1998 02.12 SPDES Permit

RE: DEC #4-0103-00016/00020
SPDES #NY-0004880
Norlite Corporation
Cohoes (City), Albany County

Re: Wastewater Treatment Plant
SPDES Permit #NY 000 4880

Re: Request for Modification of Norlite Corporation SPDES Permit No. NY 0004880.

FIGURE 1

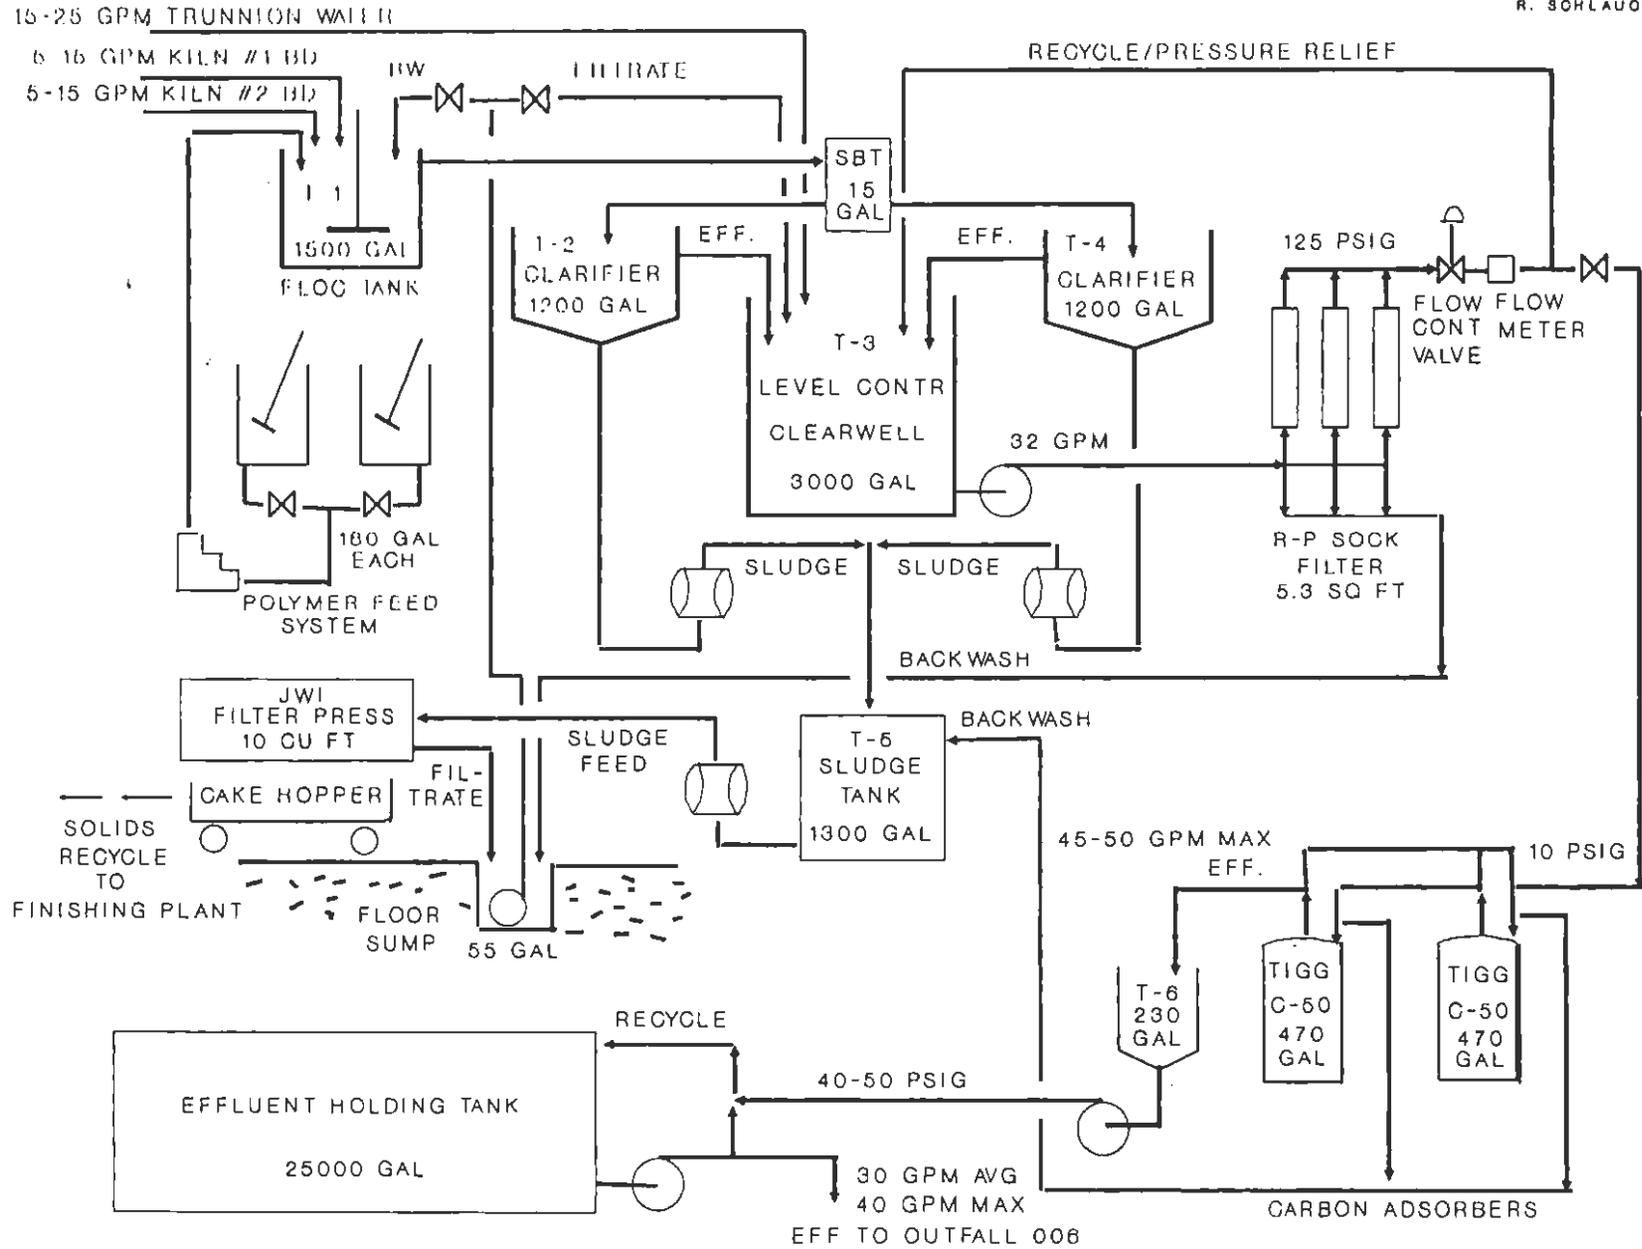
Since the wastewater discharge from Norlite's existing wastewater treatment process did not create hydrogen sulfide problems in the storm sewer during the period between November 1994 and April 1995, it is apparent that the effluent discharge system modifications made during April, May and June are the probable cause. Because these modifications eliminated repumping and recirculation and bottom discharge in the effluent holding tank, anaerobic conditions (which are essential for bacterial hydrogen sulfide generation) were inadvertently promoted.

FIGURE 2

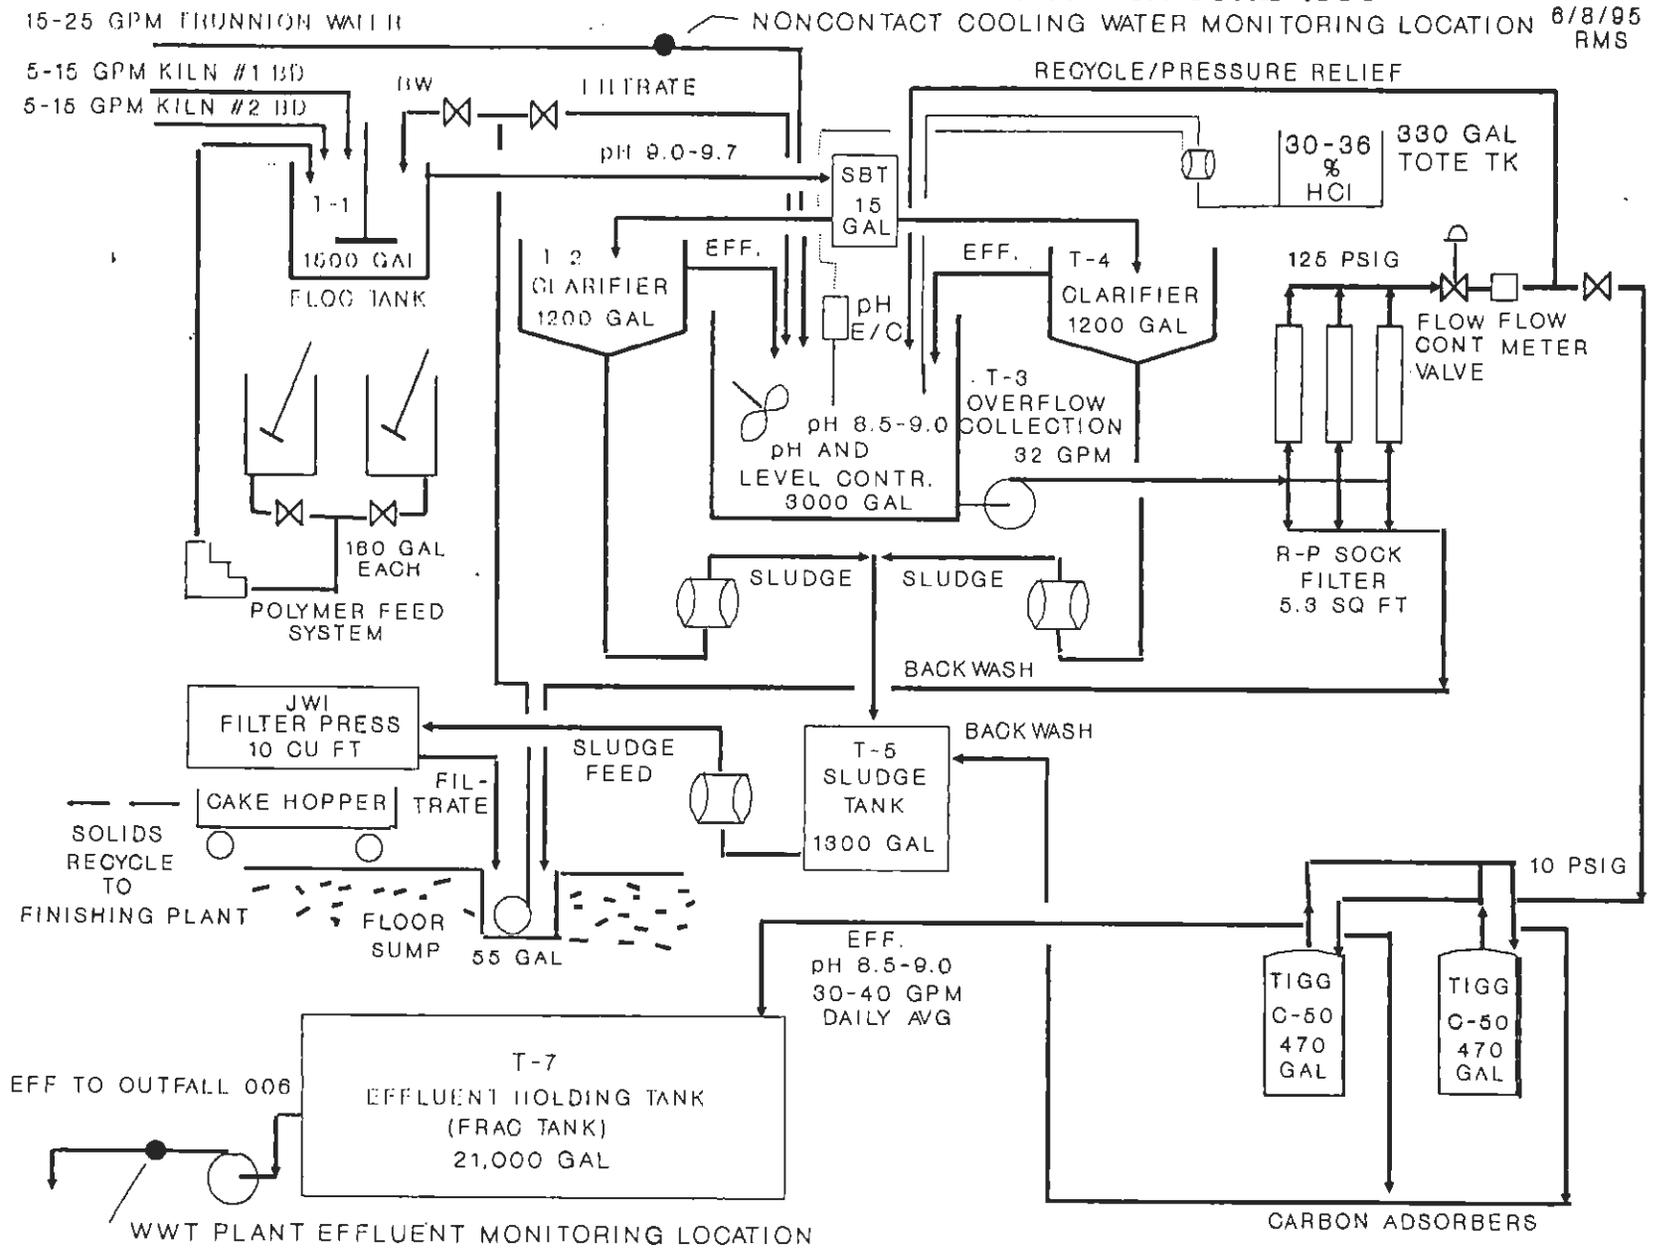
In March-April 1995, this WWT effluent storage tank was taken out of WWT service and a 20,000 gallon bottom discharge "frac" tank was rented to take its place. When placed in service, this "frac" tank was not provided with discharge recirculation (See Figure 2). Further, the water level was allowed to alternate

FIGURE 3

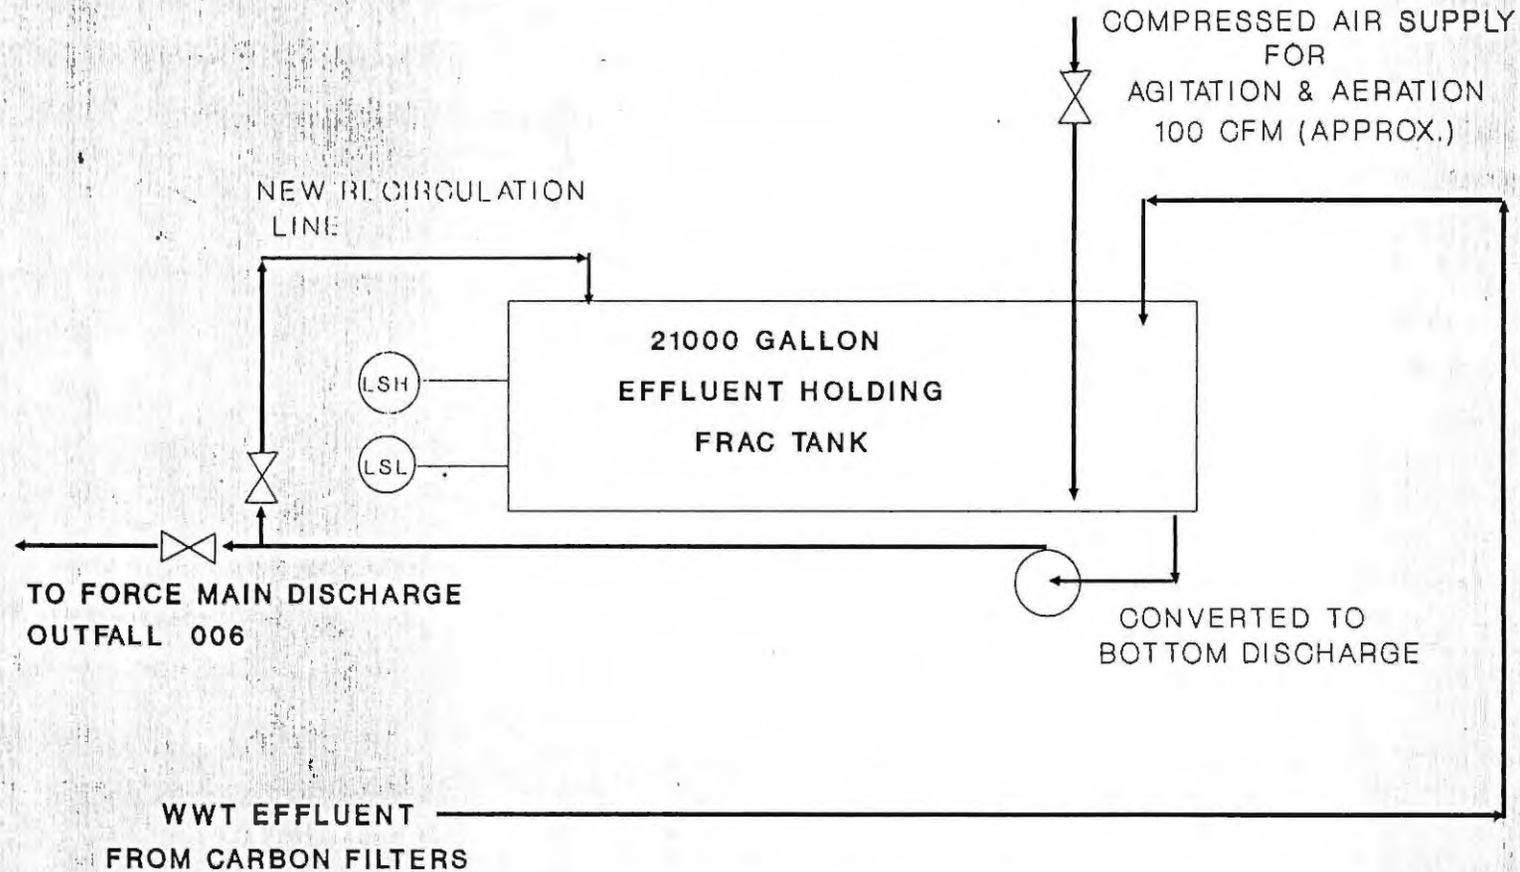
The remedy is not difficult. Agitation, aeration and recirculation will restore the effluent holding tank to an aerobic condition and eliminate this tank as a source of hydrogen sulfide generation. These process conditions are being implemented through the following system modifications; (See Figure 3).

- 3.1 A recirculation flow from the effluent discharge pump is being installed to provide agitation and increased air contact.
- 3.2 A bottom discharge from the effluent holding tank has been installed to minimize residence time and stagnant zones within the vessel.
